ERA: ADG Solar Access Compliance		No	Has no effect on compliance %		25/06/2025
Council RFI dated 19 June - FK Response Table		Yes	Has positive effect on compliance %		
		Yes	Has negative effect on compliance %

Item	Description	Affects Compliance %	Action or additional information to be provided	Council Method of Analysis	FK Method of Analysis
	General note on FK response and additional analysis:		<p>Council’s Request for Information (RFI) dated 19 June requested a reanalysis of solar access for more than 60 units, with only 2.5 working days provided to complete the task. Assessing solar access at an individual unit level is a detailed and time-intensive process, with each analysis potentially taking several hours to complete.</p> <p>In line with the structure and focus of Council’s RFI, our initial review concentrated on the MOD 2 scheme. Upon reviewing Council’s queries, we found that the majority of our previously stated results were confirmed as accurate. Given the limited timeframe, our analysis prioritised units where Council identified a reduction in solar access compared to our earlier assessment. Due to time constraints, we were unable to fully investigate the units where

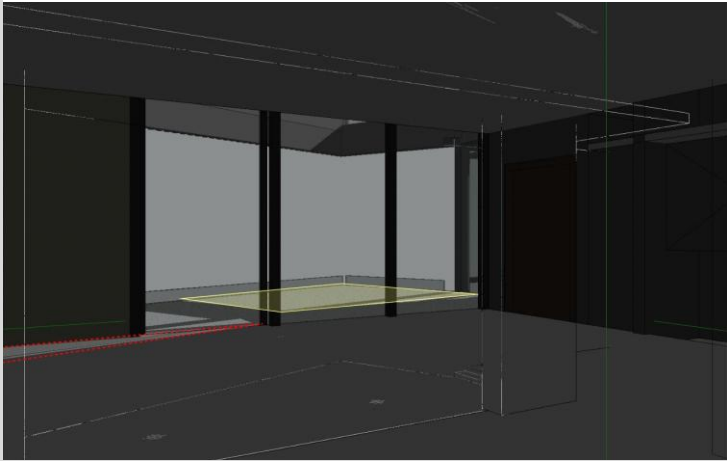
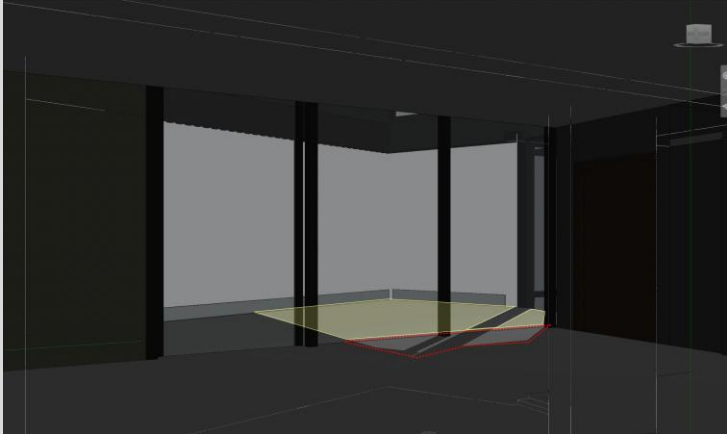
3	FK identifies the Tower B east facing apartments as receiving 1hr 30mins solar access to the living rooms (see pages 14-16 of Appendix 2) under MOD 1. However, these same apartments are identified as receiving 1hr 45mins solar access to the living rooms under the current modification. It is noted the additional solar analysis provided on pages 11 and 12 of Appendix 3 to demonstrate that the Tower B east facing apartments generally receive 1hr 45mins solar access to the living rooms (the expecting being the 1-bedroom apartments at Level 8 and above) in accordance with the '1sqm @ 1 meter above FFL criteria, is accepted by CN. As such, it is unclear why the calculations for the MOD 1 have identified these apartments as receiving only 1hr 30mins solar access, rather than the 1hr 45mins		FK response - This discrepancy is due to a change in the angle and spacing of privacy louvres to these apartments. In MOD 2 privacy louvres wre changed from being perpendicular to the façade, to being angled towards the sun. Additionally, spacing between the louvres was increased. Both these design changes allowed more sunlight to access apartments between the louvres. See louvres on plans below:

MOD 1 apartment plan with perpendicular privacy louvres			
		MOD 2 apartment plan with angled privacy louvres allowing better sunlight access			
4	The apartment numbers have been omitted from all the updated 'PROPOSED SOLAR ACCESS DIAGRAMS' drawings. All floor plans need to be updated to label the apartment numbers		FK response - Unit numbers have been updated in the solar access diagrams		
Assessment of Apartments:					
	A breakdown of CN's assessment and the analysis provided by FK is provided below. Further justification is required for the original DA and MOD 1.				
5	Original DA - Living Areas				
a	Eastern façade Tower B - Level 4-13 - amend from 1hour 45mins to 1hour 30mins	No	FK response - Rechecking of sun eye view diagrams has confirmed that units receive 1.45 HRS sunlight from 9 - 10.45 AM	Sun Eye View	Re-checking of Sun Eye View diagrams
b	Amend B115-B118 from 1hour 45mins to 1hour 15mins - overshadowed by the Wests Club.	No	FK response - Rechecking of sun eye view diagrams has confirmed that units recieve 1.30 HRS sunlight from 9.30 - 11 AM	Sun Eye View	Re-checking of Sun Eye View diagrams

811 B - Living 11:55 AM

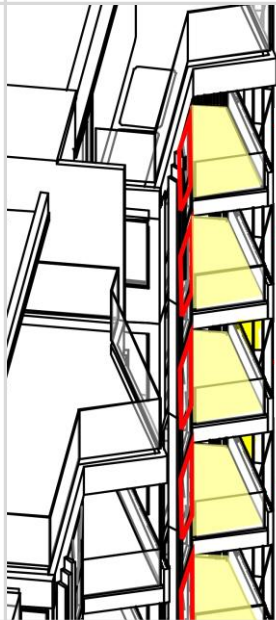
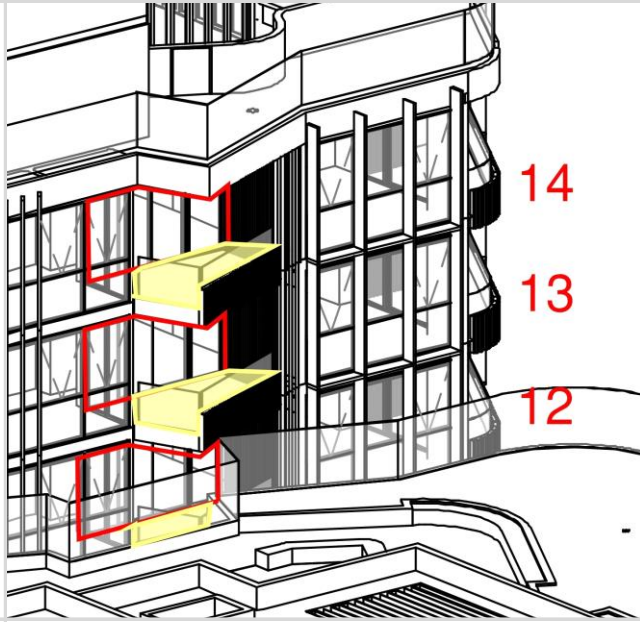
811 B - Living 1.30 PM			
b	Alternatively, the documentation needs to be amended to reflect CN's assessment. Specifically,				
i	The colour coded floor plan diagrams ('PROPOSED SOLAR ACCESS DIAGRAMS' drawing no. DA517) need to be updated to show apartment 811B coloured orange to indicate the living room has been included in the '<1hr 30mins' calculations. The accompanying calculation breakdowns need to be updated accordingly.		Not applying this option		
7	811B Balconies - FK identifies apartment 811B as receiving 2hr solar access to the balconies (see 'PROPOSED SOLAR ACCESS DIAGRAMS' drawing no. DA517-A). However, analysis of the relevant view of the sun diagrams found apartment 811B receives solar access to the balcony at 11:45am, 12:00noon, 12:15pm, 12:30pm, 12:45pm, 1pm, 1:15pm, and 1:30pm, but are overshadowed by Tower A by 1:45pm. This is 1hr 45mins.				
a	Further details need to be submitted to demonstrate how FK achieved the results stated. Specifically:

Unit 811 B - Receives 1.30Hrs sunlight from 11.55 - 1.30 Pm

811B - Balcony 11:55 AM

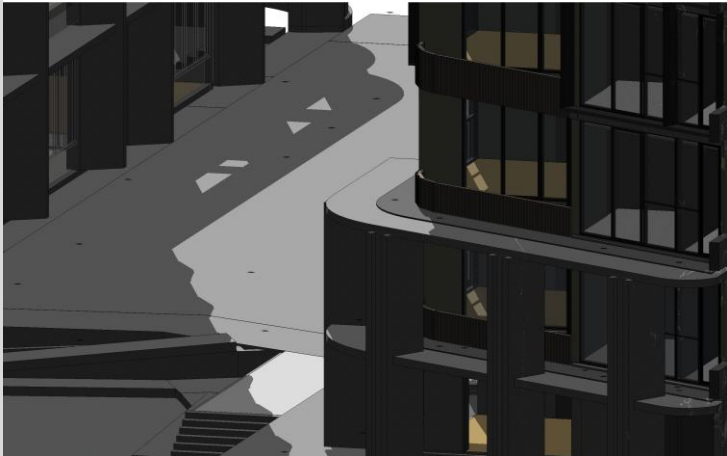
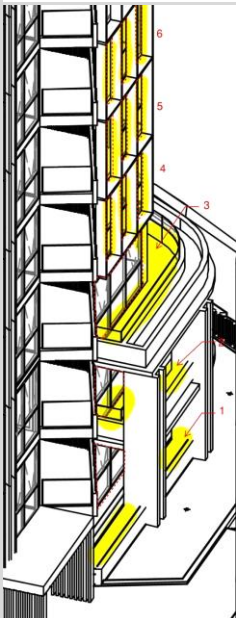
811 B - Balcony 1.30 PM			
b	Alternatively, the documentation needs to be amended to reflect CN's assessment. Specifically,				
i	The colour coded floor plan diagrams ('PROPOSED SOLAR ACCESS DIAGRAMS' drawing no. DA517-A) need to be updated to show apartment 811B coloured brown to indicate the balcony has been included in the '1hr 45mins' calculations. The accompanying calculation breakdowns need to be updated accordingly.		Not applying this option		
8	911B Living Room - FK identifies apartment 911B as receiving 1hr 30mins solar access to the living room (see 'PROPOSED SOLAR ACCESS DIAGRAMS' drawing no. DA517). However, analysis of the relevant view of the sun diagrams found apartment 911B receive solar access to the living room at 1:15pm, 1:30pm and 1:45pm, but is overshadowed by Tower A by 2pm. This is 30mins.				
a	Further details need to be submitted to demonstrate how FK achieved the results stated. Specifically:

i	how the balcony of apartment 811B receives solar access for 2hrs accounting for overshadowing from Tower A.		<div>FK response - To achieve solar access for these apartments, sunlight passes through bedroom glazing on the facade, and into living rooms at the back of the balcony. Figure A illustrates this principle and shows the living room window behind the bedroom outlined with a red dashed line. This condition recurs in a number of apartments. These units recieve less than 2 hours sunlight and therefore do no affect the overall compliance percentage</div> <div>Unit 811 B - Receives ` 2HRS sunlight from 11.35 - 1.40PM</div>	Sun Eye View	Sun Eye View

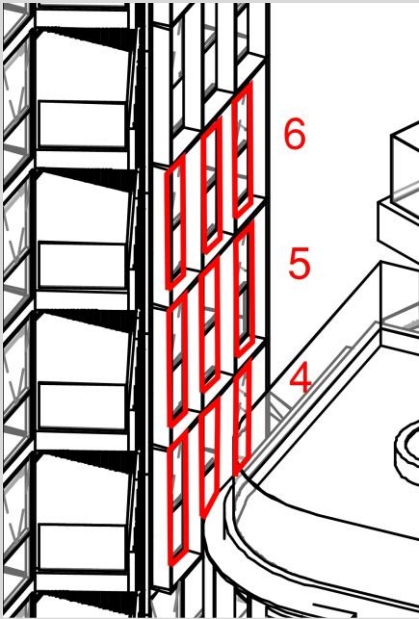
811B - Living 11:55 AM			
		811B - Living 1.30 PM			
b	Alternatively, the documentation needs to be amended to reflect CN's assessment. Specifically,				
i	The colour coded floor plan diagrams ('PROPOSED SOLAR ACCESS DIAGRAMS' drawing no. DA517) need to be updated to show apartment 911B coloured orange to indicate the living room has been included in the '<1hr 30mins' calculations. The accompanying calculation breakdown needs to be updated accordingly.		Not applying this option		
9	1011B Living Room - FK identifies apartment 1011B as receiving 2hr solar access to the living room (see 'PROPOSED SOLAR ACCESS DIAGRAMS' drawing no. DA517). However, analysis of the relevant view of the sun diagrams found apartment 1011B receives solar access to the living room at 1:15pm, 1:30pm, 1:45pm, and 2pm, but is overshadowed by Tower A by 2:15pm. This is 45mins.				
a	Further details need to be submitted to demonstrate how FK achieved the results stated. Specifically:

i	how the living rooms of apartment 911B receives solar access for 1hr 30mins, accounting for overshadowing from Tower A.		FK response - To achieve solar access for these apartments, sunlight passes through bedroom glazing on the facade, and into living rooms at the back of the balcony. Figure A illustrates this principle and shows the living room window behind the bedroom outlined with a red dashed line. This condition recurs in a number of apartments. These units recieve less than 2 hours sunlight and therefore do no affect the overall compliance percentage	Sun Eye View	Sun Eye View
			Unit 911 B - Receives 1.30 Hrs sunlight from 11.55 - 1.30 Pm

1011B - Living 11:55 AM

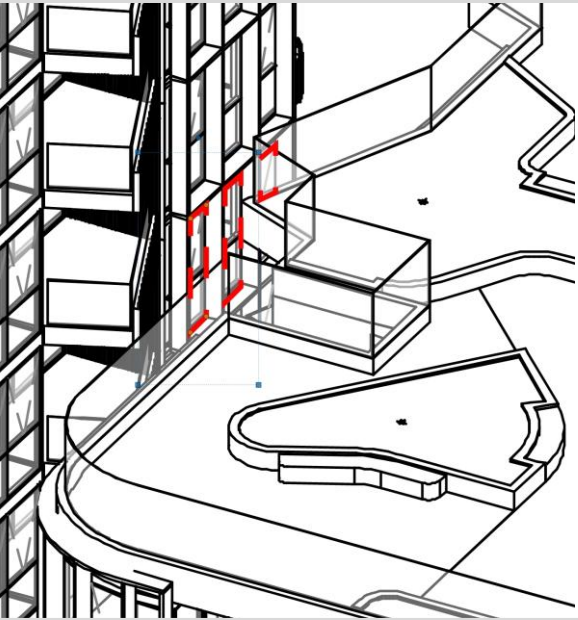
1011B - Living 2:15 PM			
b	Alternatively, the documentation needs to be amended to reflect CN's assessment. Specifically,				
i	The colour coded floor plan diagrams ('PROPOSED SOLAR ACCESS DIAGRAMS' drawing no. DA517) need to be updated to show apartment 1011B coloured orange to indicate the living room has been included in the '<1hr 30mins' calculations. The accompanying calculation breakdown needs to be updated accordingly.		Not applying this option		
10	1111B Living Room - FK identifies apartment 1111B as receiving 2hr solar access to the living room (see 'PROPOSED SOLAR ACCESS DIAGRAMS' drawing no. DA517). However, analysis of the relevant view of the sun diagrams found apartment 1111B receives solar access to the living room at 1:15pm, 1:30pm, 1:45pm, 2pm, 2:15pm, and 2:30pm, but is overshadowed by Tower A by 2:45pm. This is 1hr 15mins.				
a	Further details need to be submitted to demonstrate how FK achieved the results stated. Specifically:

i	how the living rooms of apartment 1011B receive solar access for 2hrs, accounting for overshadowing from Tower A.		FK response - To achieve solar access for these apartments, sunlight passes through bedroom glazing on the facade, and into living rooms at the back of the balcony. Figure A illustrates this principle and shows the living room window behind the bedroom outlined with a red dashed line. This condition recurs in a number of apartments. These units recieve less than 2 hours sunlight and therefore do no affect the overall compliance percentage	Sun Eye View	Sun Eye View
			Unit 1011 B - Receives 2 Hrs sunlight from 11.55 - 2.15 Pm

1111B Living - 11:55 AM

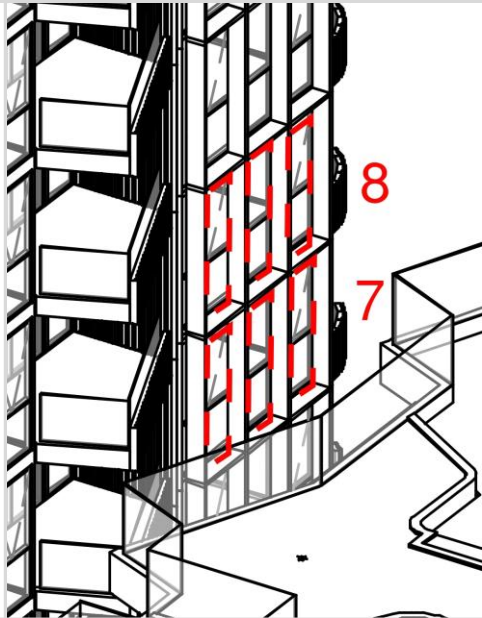
1111B Living - 2.15 PM			
b	Alternatively, the documentation needs to be amended to reflect CN's assessment. Specifically,				
i	The colour coded floor plan diagrams ('PROPOSED SOLAR ACCESS DIAGRAMS' drawing no. DA517) need to be updated to show apartment 1111B coloured orange to indicate the living room has been included in the '<1hr 30mins' calculations. The accompanying calculation breakdowns need to be updated accordingly.		Not applying this option		
11	1211B, 1311B, and 1411B Living Room - FK identifies these apartments as receiving 2hr solar access to the living room (see 'PROPOSED SOLAR ACCESS DIAGRAMS' drawing no. DA518). However, analysis of the relevant view of the sun diagrams found these apartments receive solar access to the living room at 1:15pm, 1:30pm, 1:45pm, 2pm, 2:15pm, 2:30pm, 2:45pm, and 3pm, which equates to 1hr 45mins.				
a	Further details need to be submitted to demonstrate how FK achieved the results stated. Specifically:

i	how the living rooms of apartment 1111B receive solar access for 2hrs, accounting for overshadowing from Tower A.		FK response - To achieve solar access for these apartments, sunlight passes through bedroom glazing on the facade, and into living rooms at the back of the balcony. Figure A illustrates this principle and shows the living room window behind the bedroom outlined with a red dashed line. This condition recurs in a number of apartments. These units recieve less than 2 hours sunlight and therefore do no affect the overall compliance percentage Unit 1111 B - Receives 2 Hrs sunlight from 11.55 - 2.15 Pm	Sun Eye View	Sun Eye View

1211B, 1311B, 1411B - Living Rooms 11:55 AM

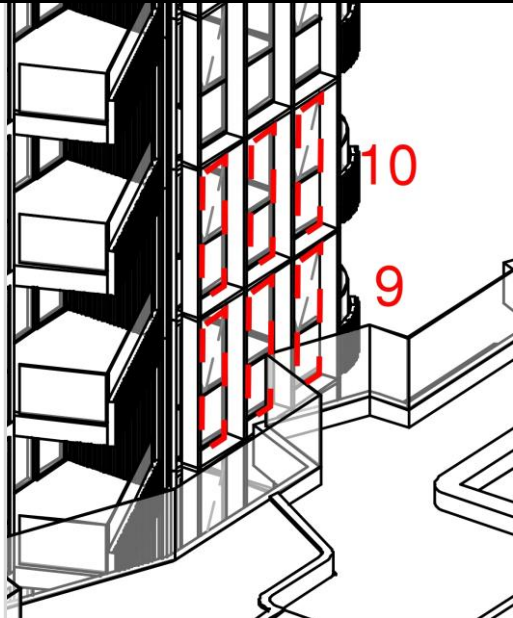
1211B, 1311B, 1411B Living Rooms 3.00 PM			
b	Alternatively, the documentation needs to be amended to reflect CN's assessment. Specifically,				
i	The colour coded floor plan diagrams ('PROPOSED SOLAR ACCESS DIAGRAMS' drawing no. DA518) need to be updated to show these apartments coloured brown to indicate the living room has been included in the '<1hr 45mins' calculations. The accompanying calculation breakdowns need to be updated accordingly.		Not applying this option		
12	108B, 210B, and 310B Living Rooms - FK identifies these apartments as receiving <1hr 30mins solar access to the living rooms (see 'PROPOSED SOLAR ACCESS DIAGRAMS' drawing no. DA516). Specifically, FK states these apartments receive solar access from 1pm until 2:10pm, totalling 1hr 10mins (see apartment typology solar analysis, page 12 of Appendix 3). However, analysis of the relevant view of the sun diagrams found these apartments receive solar access to the living rooms at 1pm, but are overshadowed by Tower A by 1:15pm. Whilst this is less then 15mins, it appears FK has overlooked that the exterior façade extrusions which occur around the living room windows of the southwest corner apartments at Level 4 and above are omitted from the Level 1 to Level 3 apartments. As a result, the living rooms of these apartments potentially receive solar access from as early as 12:30pm.

i	how the living rooms of these apartments receive solar access for 2hrs.		FK response - To achieve solar access for these apartments, sunlight passes through bedroom glazing on the facade, and into living rooms at the back of the balcony. Figure A illustrates this principle and shows the living room window behind the bedroom outlined with a red dashed line. This condition recurs in a number of apartments. These units recieve less than 2 hours sunlight and therefore do no affect the overall compliance percentage	Sun Eye View	Sun Eye View
			Unit 1211B - Receives 2 Hrs sunlight from 11.55 -3.00 Pm		
			Unit 1311B - Receives 2 Hrs sunlight from 11.55 -3.00 Pm		
			Unit 1411B - Receives 2 Hrs sunlight from 11.55 -3.00 Pm

Unit 108B receives <1.30 HRS sunlight from 11.55 to 1.00 PM		
			Unit 210B receives <1.30 HRS sunlight from 11.55 to 1.00 PM		
			Unit 310 receives <1.30 HRS sunlight from 11.55 to 1.00 PM

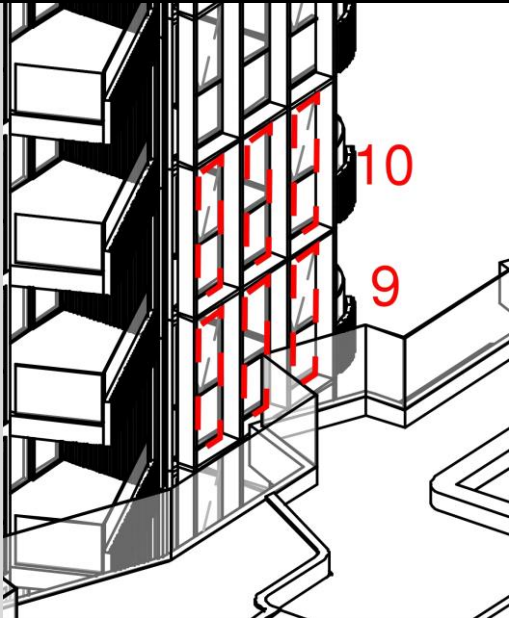
13	108B, 210B, and 310B Balconies - FK identifies these apartments as receiving <1hr 30mins solar access to the balconies (see 'PROPOSED SOLAR ACCESS DIAGRAMS' drawing no. DA516-A). Specifically, FK states these apartments receive solar access from 1pm until 2:10pm, totalling 1hr 10mins (see apartment typology solar analysis, page 12 of Appendix 3). However, analysis of the relevant view of the sun diagrams found these apartments receive solar access to their balconies at 1pm, but are overshadowed by Tower A by 1:15pm. Whilst this is less than 15mins, it appears FK has overlooked that these apartments benefit from extended balconies due to the podium-like design of Level 1 to Level 3 and as such the balconies potentially receive solar access from as early as 12:15pm.				
a	Further details need to be submitted to demonstrate how FK achieved the results stated. Specifically:				
i	how the balconies of these apartments receive solar access at 1:15pm until 2:10pm, accounting for overshadowing from Tower A.			Sun Eye View	Sun Eye View/3D Model Analysis

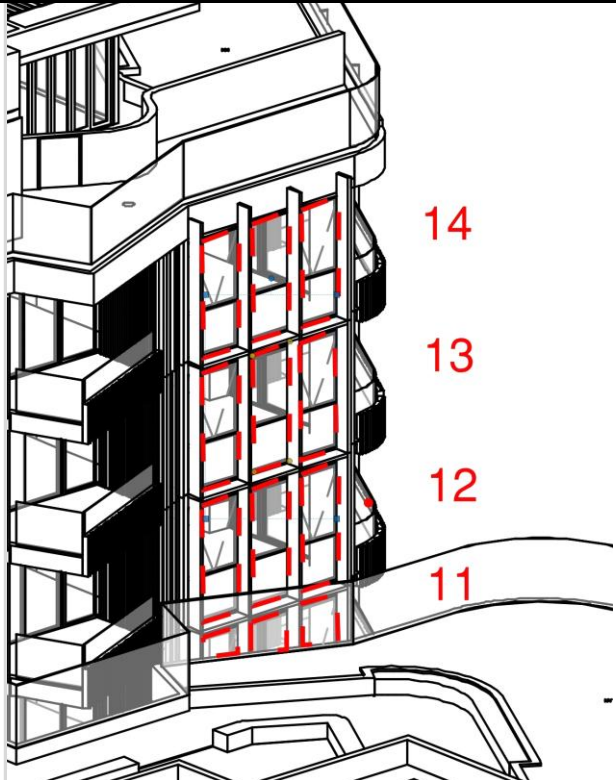
14	410B and 510B Living Room and Balcony - FK seeks to rely solely on sunlight passing through the living room onto the balcony of these apartments for the purposes of considering the solar access requirements described in the ADG (see apartment typology solar analysis, page 12 of Appendix 3). In principle, CN accepts this premise. As such, the comments below are relevant to both the living room and balcony of these apartments.				
	<ul style="list-style-type: none">FK identifies these apartments as receiving <1hr 30mins solar access to the living room, while also identifying the balcony as receiving 1hr 30mins solar access (see 'PROPOSED SOLAR ACCESS DIAGRAMS' drawing no. DA516 and DA516-A respectively).Specifically, FK states the balcony of apartment 910B receives solar access from 1pm until 2:35pm, totalling over 1hr 30mins (see apartment typology solar analysis, page 12 of Appendix 3). Given the balconies rely on sunlight passing through the apartment living rooms onto the balconies, it is unclear how the balconies could be achieving greater solar access than the living rooms.

Regardless of this identified inconsistency, analysis of the relevant view of the sun diagrams found these apartments receive solar access to the living room (and therefor the balcony) at 1pm, but are overshadowed by Tower A by 1:15pm. This is less than 15mins.				
	<ul style="list-style-type: none">Given the abovementioned overshadowing from Tower A observed at 1:15pm, it is unclear how the additional 3D solar analysis views provided on page 12 of Appendix 3 show sunlight entering the living room and onto the balcony of these apartments at 1:15pm and beyond.Given a minimum of '1sqm @ 1 meter above FFL for a period of 15mins' has not been demonstrated, it is CN's assessment the living rooms of these apartments should be included in the 'No Solar' calculation.				
a	Further details need to be submitted to demonstrate how FK achieved the results stated. Specifically:				
i	how the balcony (and therefor the living room) of these apartments receive solar access at 1:15pm until 2:35pm, accounting for overshadowing from Tower A.		FK response - FK model analysis was correct. However, times were annotated incorrectly. Living room and balcony sunlight timeframes updated in APPENDIX 3 as per CN comments. Units 410B and 510B receive sun from 11.55 AM until 1:00 PM	Sun Eye View	Sun Eye View

Refer to Figure B showing sunlight at starting at 11:55 AM		
			Unit 410B receives <1.30 HRS sunlight from 11.55 to 1.00 PM		
			Unit 510B receives <1.30 HRS sunlight from 11.55 to 1.00 PM		
		410B/510 B Living Room & Balcony - 1.00 PM			
b	Alternatively, the documentation needs to be amended to reflect CN's assessment. Specifically:				
i	The colour coded floor plan diagrams ('PROPOSED SOLAR ACCESS DIAGRAMS' drawing no. DA516 and DA516-A) need to be updated to show these apartments coloured red to indicate they have been included in the '0hrs solar access' calculations. The accompanying calculation breakdowns need to be updated accordingly.		Not applying this option		
ii	The written information on the apartment typology solar analysis on page 12 of Appendix 3 needs to be updated to correctly identify the timeframe which the living room and balcony of these apartments receive solar access, accounting for overshadowing from Tower A.		Not applying this option
